Comments on the Planning Proposal APP/24/00987 | Demolition of existing dwelling and the construction of 5 new dwellings with associated external works and landscaping. | Oklahoma, 4 Long Copse Lane, Emsworth, PO10 7UL

Executive summary

Figure 1 - Google maps image demonstrating cumulative area of gardens (green) which will be destroyed.

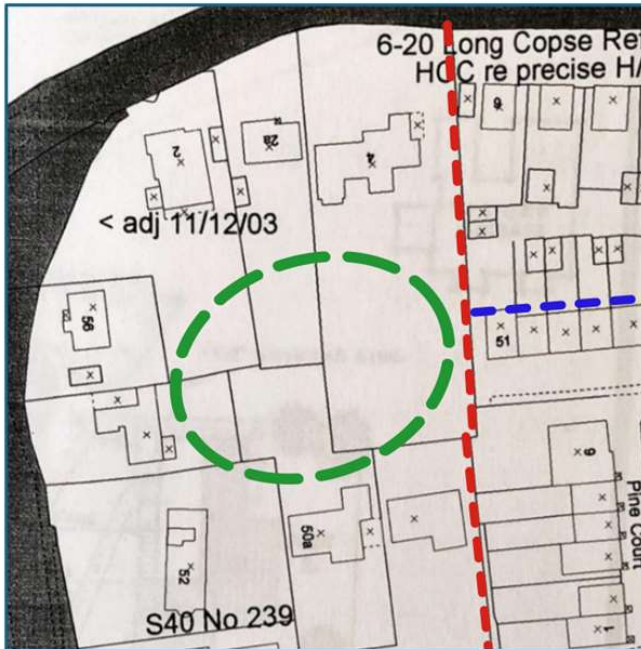
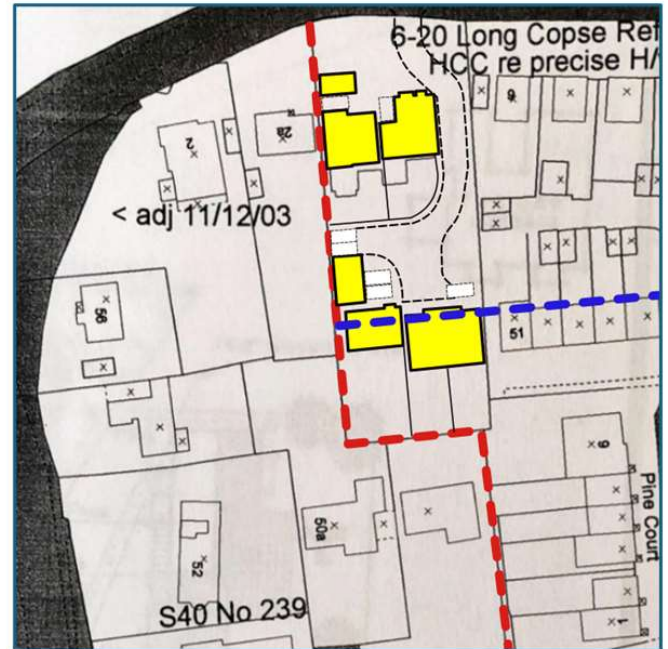
As evidenced in the snip above, the development documents acknowledge the clear difference of character of the current site and the area to the west vs. the area to the east of the current site (marked in dotted red below). The document above states that the development will change the character of the plot to become a transition area (shaded in red below). This change leads to a negative change in character of the area to the West, whilst also overshadowing the area and properties to the East and cramping the property to the South.

2) Destruction of a combined, secure and tranquil area of cumulative rear gardens

The current cumulative gardens are tranquil, shielded from all traffic and parking, and free of artificial light. The insertion of a parking and turning area and housing within this island of cumulative gardens will negatively affect all the properties in the Western area. It destroys the secure and tranquil island of cumulative garden (shown in dotted green – see also figure 5.8 on pg. 43 of *HBC Design guide*). This green core is removed and replaced with a cramped and (as will be argued in (4) below) inadequate parking area, which will lead to noise, light, and emissions pollution which will negatively affect the character of the area.

Figure 3. Overview plan of current properties (principally black outline), borders (red), proposed properties (purple) and garage (blue outline). The area of new overshadowing of Plot 2 against existing 2a is shown in green.

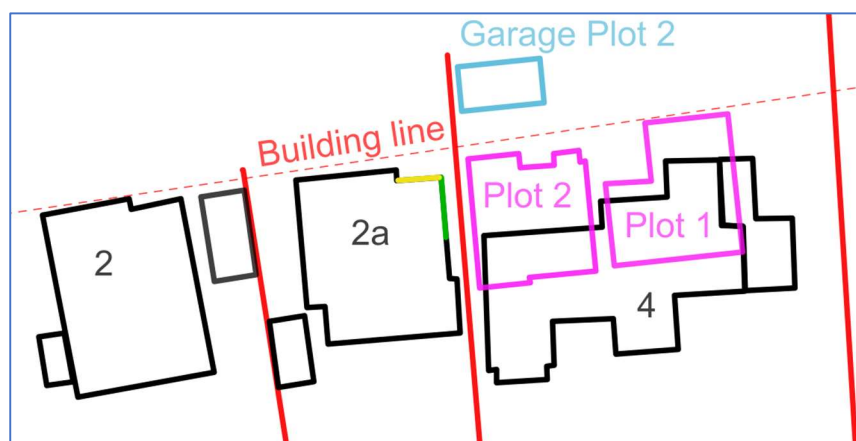
The proposed property on Plot 2 moves the northerly extent of the building further north by more than 6 metres leading to a significant new overlap with the westerly neighbour which removes light and outlook. The existing building (Oklahoma) leaves an unobstructed 4.7 metre East facing aspect (marked in green on Figures 3 & 4). The proposed building (Property 2) completely obscures and overwhelms this aspect and extends further north, darkening the area shaded yellow in Figures 3 to 5.

Figure 4. Detail showing new area of 2 storey overlap (green) by new property (pink) vs. current (black)

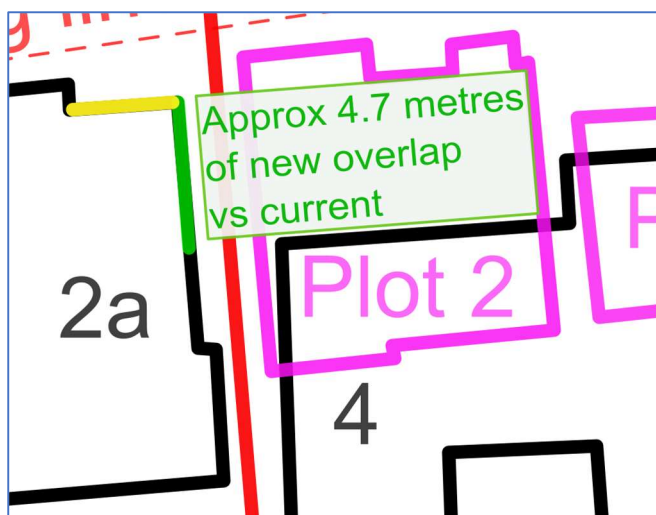
The plans show that Property 2 will be very close (approx. 2 – 2.3 metres) to the currently open eastward section of property 2a (marked in green on the plan below) at a height of 2 storeys plus the additional roof. A comparison between current (black lines) and proposed (pink lines) can be seen in the detail in Figure 4 below.

Figure 5. View looking west toward property 2a from current driveway of 4. The open area shown in green which faces east will be completely obstructed by 2 stories of the proposed property on plot 2. The current window marked in red will be completely obstructed.

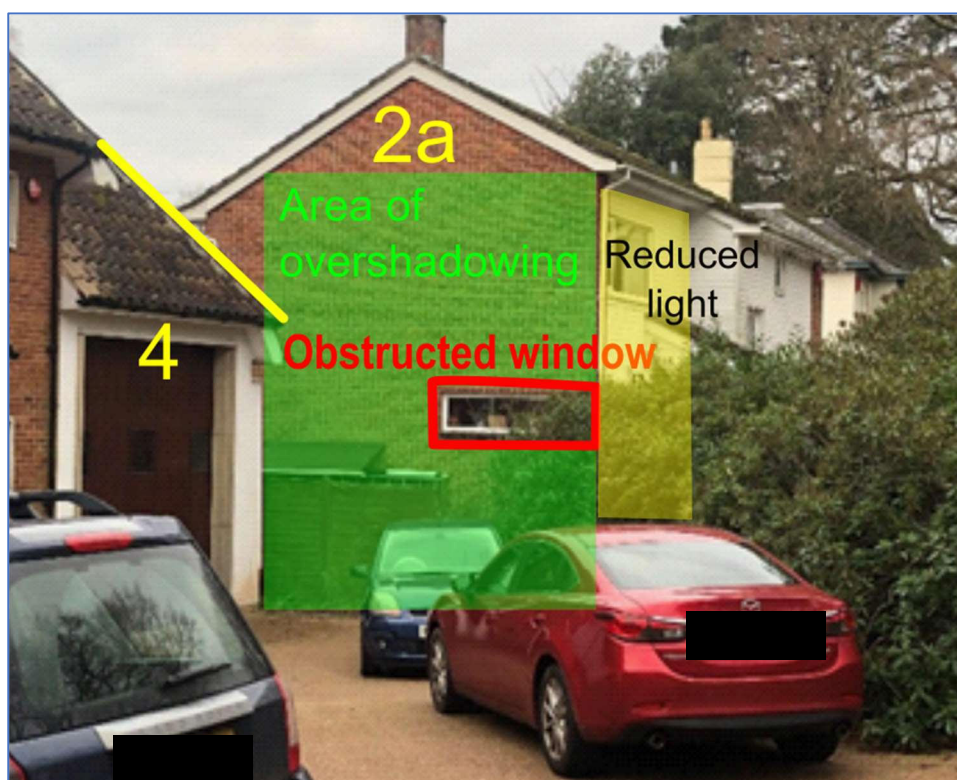
The area of obstructed light by the proposed plan shown in green above can be seen in the photograph below. This area has an existing picture window which provides an outlook to the morning sunlight (in the summer months) and an important source of light to the north easterly corner of the property labelled 2a above.

Figures 5 and 6 above demonstrate that the proposed property 2 will absolutely obscure the natural light and current outlook from this particular window of the neighbouring property. All of the proposed building clearly contravenes the daylight checking guidance of HBC Design Guide SPD (5.09 & Figure 5.2: Daylight checking for new buildings adjacent to existing homes). Furthermore, In the summer months (only), this window enjoys early morning sunlight, and this sunlight will be obscured in contravention of HBC Design Guide SPD (5.10).

Figure 10. Illustration of planned parking (PS-x) and garage (GS-x) spaces

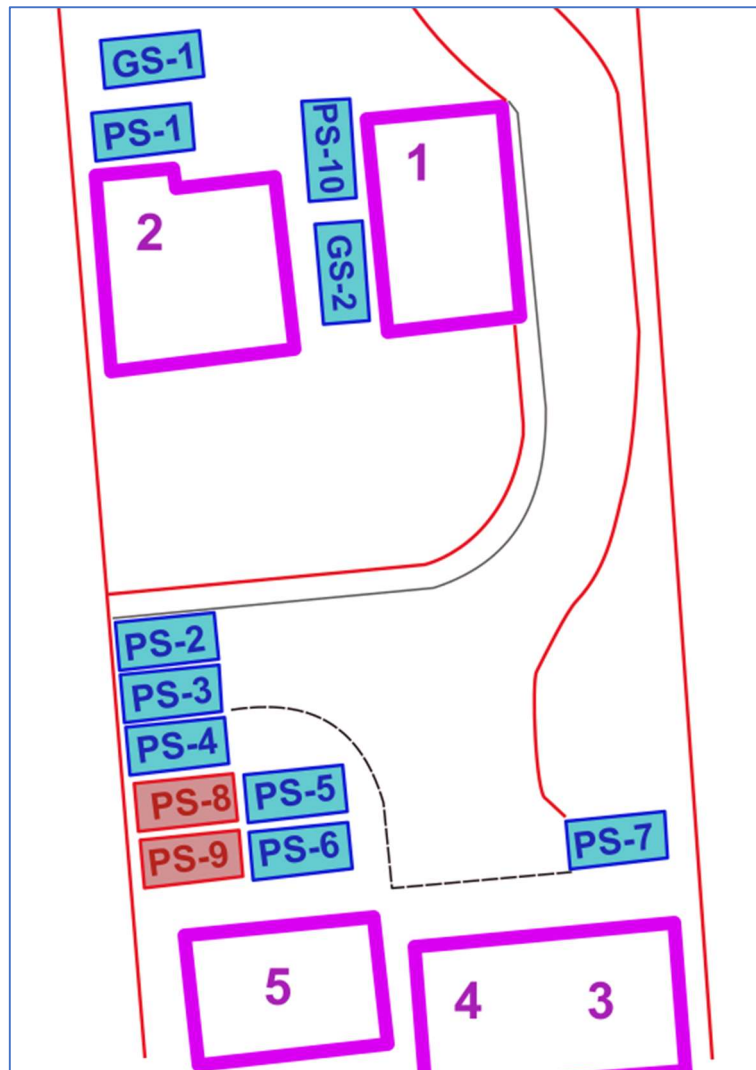
The arrangements do not allow genuine or equal access to all spaces, with at least two of the 10 proposed parking spaces (labelled as PS-8 and PS-9 in red on the adjacent diagram) potentially obstructed by others (labelled as PS-5 and PS-6 in blue on figure x). As a consequence, cars would have to be “shuffled”, leading to excessive additional noise, light and exhaust pollution for residents and neighbours. This can be expected during times of the day when there is highest home occupancy in the area, leading to maximum disruption for residents and neighbours. There is no consideration of the consequences of the inadequate parking provision within the analyses of traffic movements.

[P7 – Narrow access road] The access road to the rear parking and turning area is narrow with a pinch point of 4.1 metres and constrained by brick structures to the west and a border to the east.

There is no passing area. When vehicles meet from opposing directions on this access road, there will be limited passing room and one of these vehicles will have to reverse skilfully, either within the constrained lower area or into the main thoroughfare. This problem is compounded by a lack of visibility of the exit of the access road when leaving parking spaces PS-2 to PS-9 (excluding PS-7) which do not allow visibility of the whole of the access road.
